CITY OF ALBUQUERQUE

**RE: Saranam Golf Course & Montano
4701 Montano Rd NW
Grading and Drainage Plan
Engineer's Stamp Date: 1/4/2022
Hydrology File: E11D013B**

Based upon the information provided in your submittal received 1/4/2022, the Grading & Drainage Plan is **not** approved for Building Permit. The following comments need to be addressed for approval of the above referenced project:

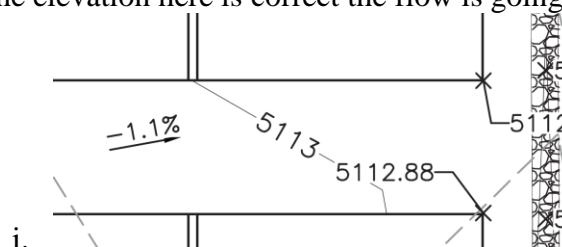
1. The Basin Map does not appear to reflect the same buildings as the G&D Sheets.
 - a. Additionally, it appears flow is directly differently.
 - b. Ensure cross lot drainage is established (easement) if that is the plan and show how this will be routed to the proper location overall. We need to know where the water ends up ultimately.

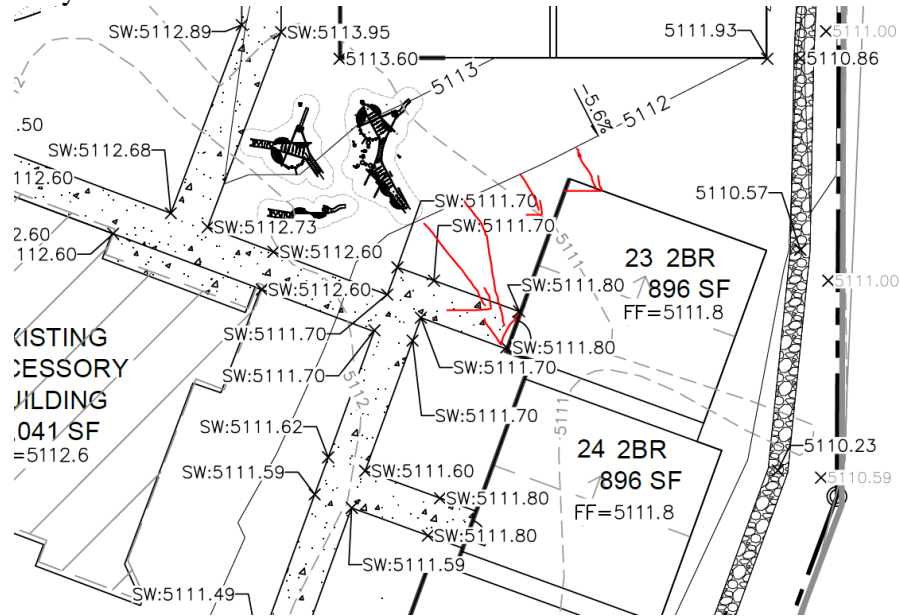
8. Please reference DPM Chapter 6.
9. Please take a second look at everything. See below, it appears flow may go directly into the doorways here.

SHEET C2.3

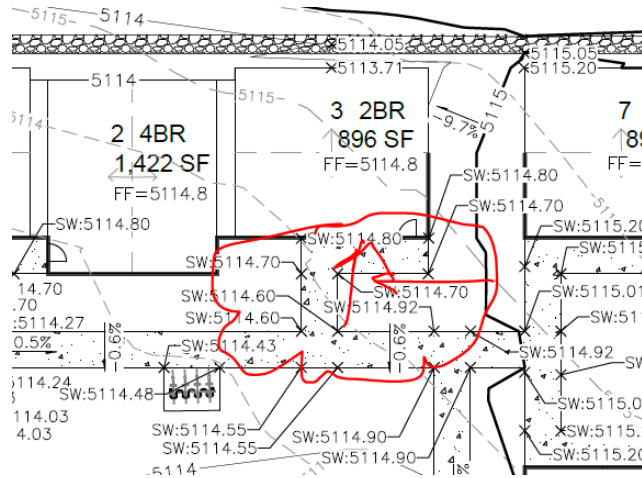
3. Check this area. Appears maybe some ponding and may flow right to the doorway area here.

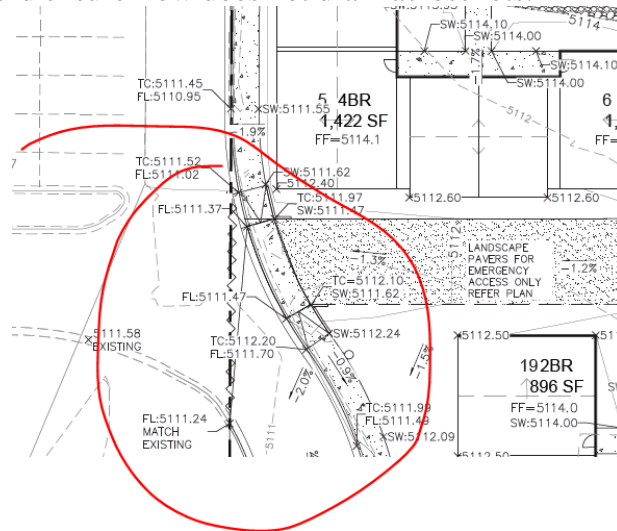
- a.
4. Is this a water block? If so, please provide elevations showing how these grades will work and ensure flow does not drain across lots.

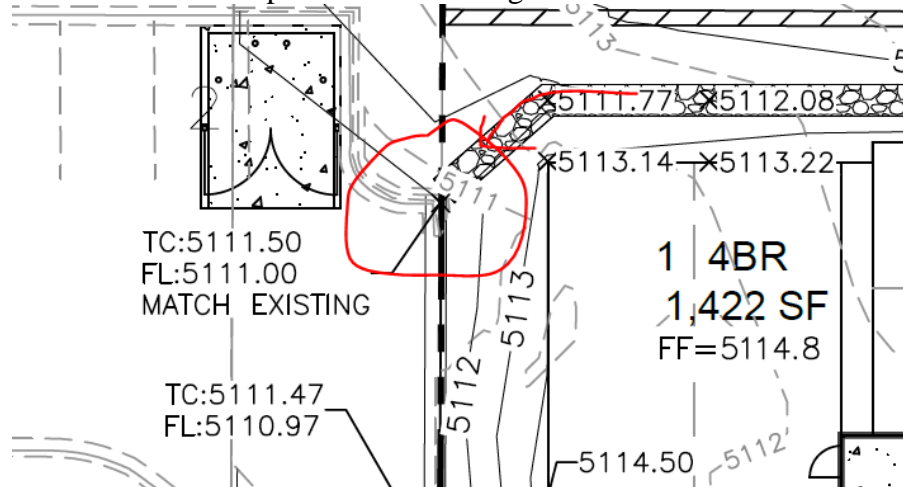
- a.
5. Where does this flow end up? Cross lot drainage?

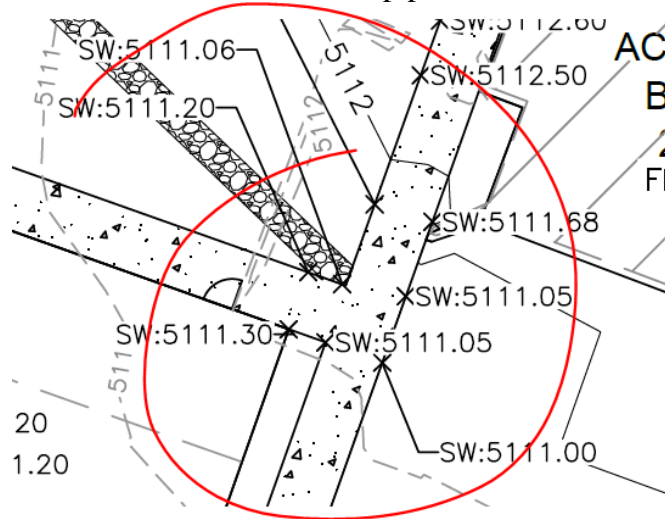
7. How will this work? Will there be a pipe under sidewalk?

- a.
- b. Please show all of these details. As of now it appears this is just a ponding area.

ENGINEER'S SEAL	SARANAM AT 4701 MONTANO RD NW BASIN MAP PLAN	DRAWN BY LN
			DATE 10/20/2021
			2019080_GRE
			SHEET # C2.1 JOB # 2019080

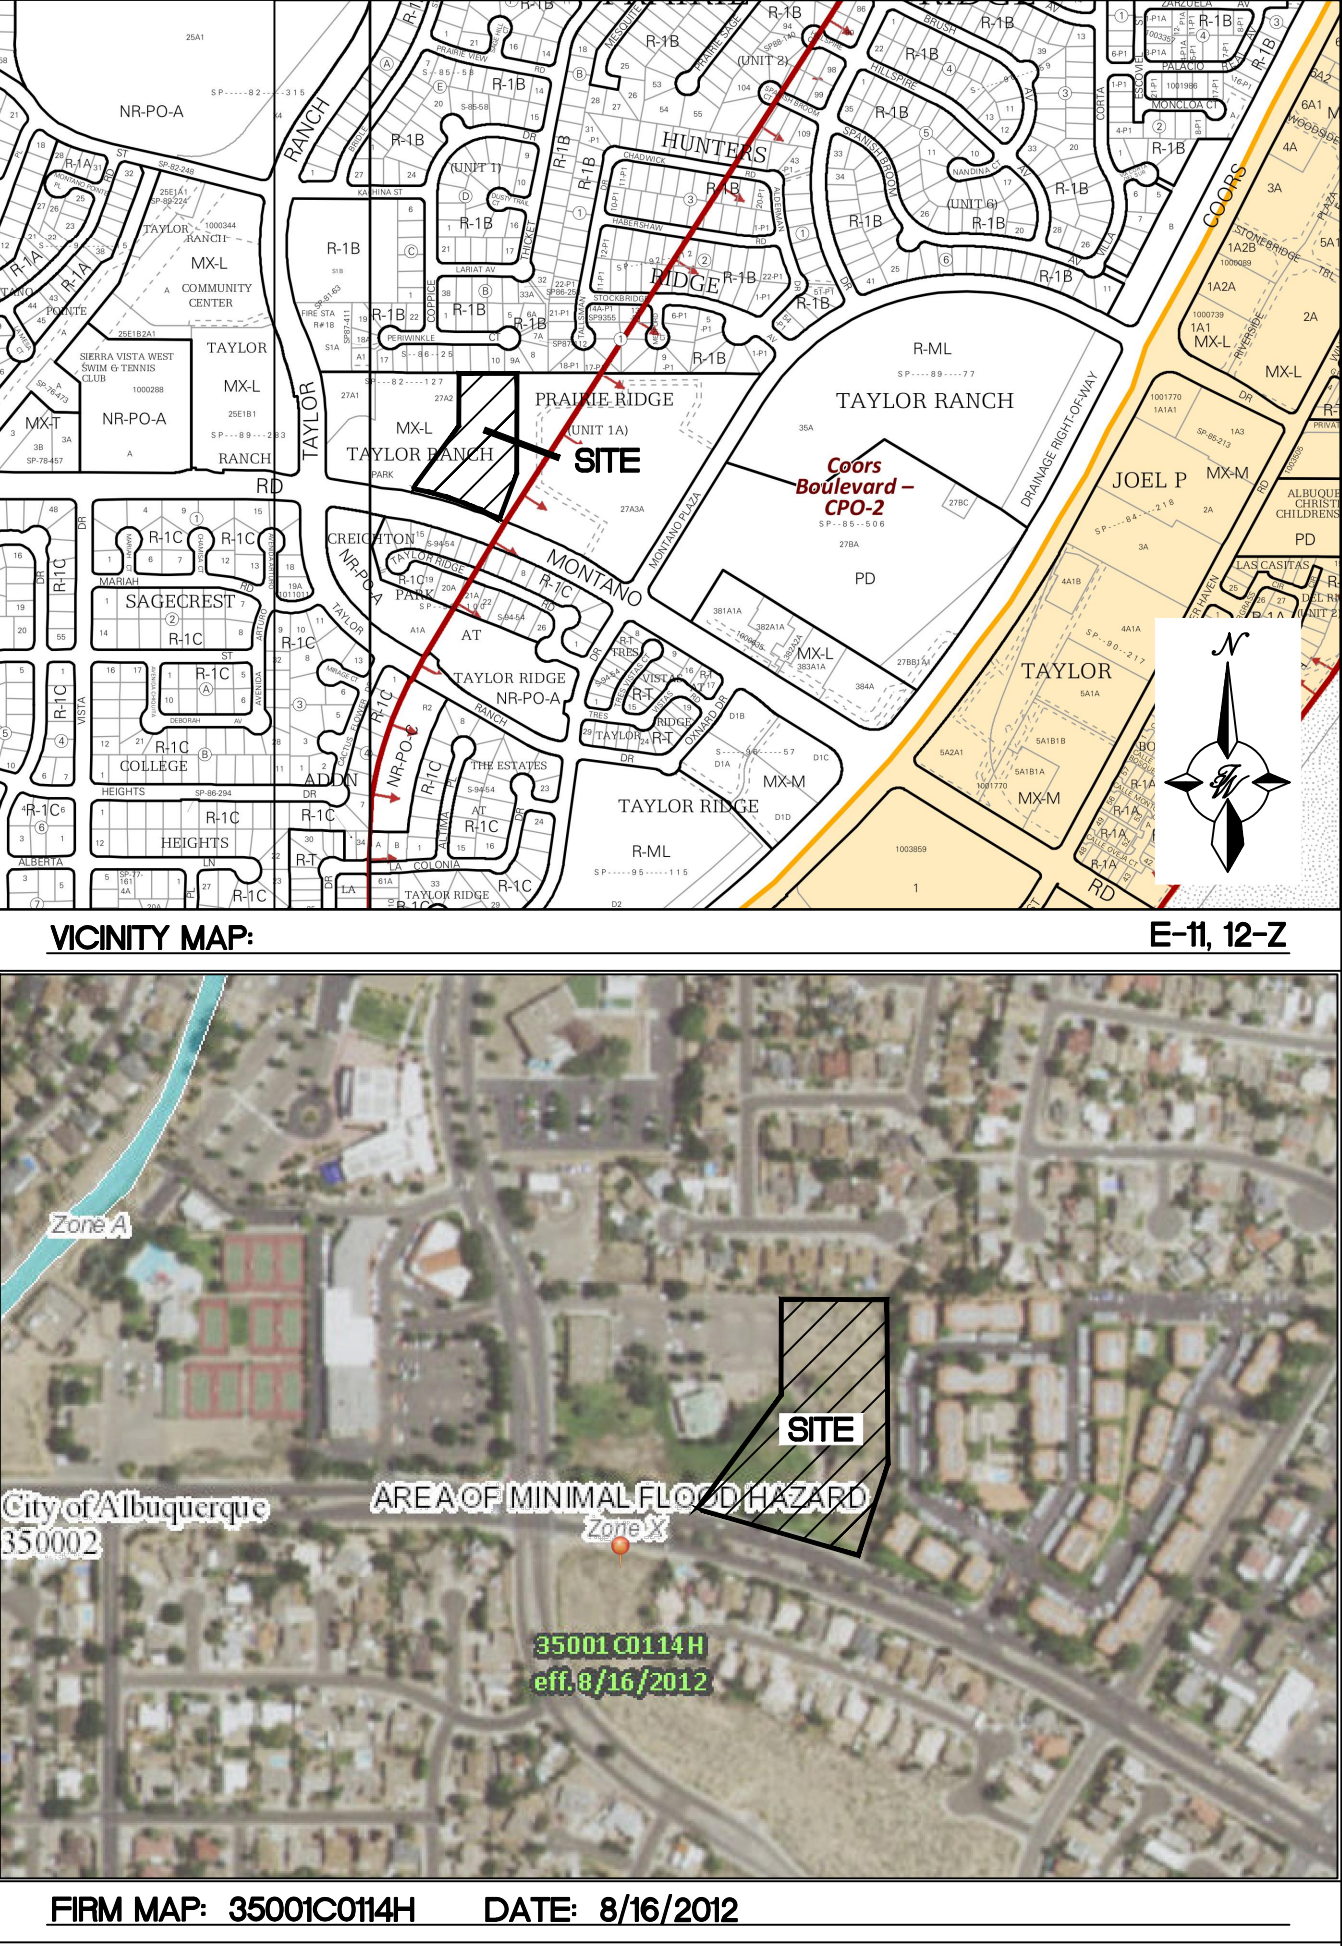
1. Please double check the calculations for the tables provided. I checked a couple and did not come up with the same.
2. Please include the required volume for retention. (100-year, 10-day storm)
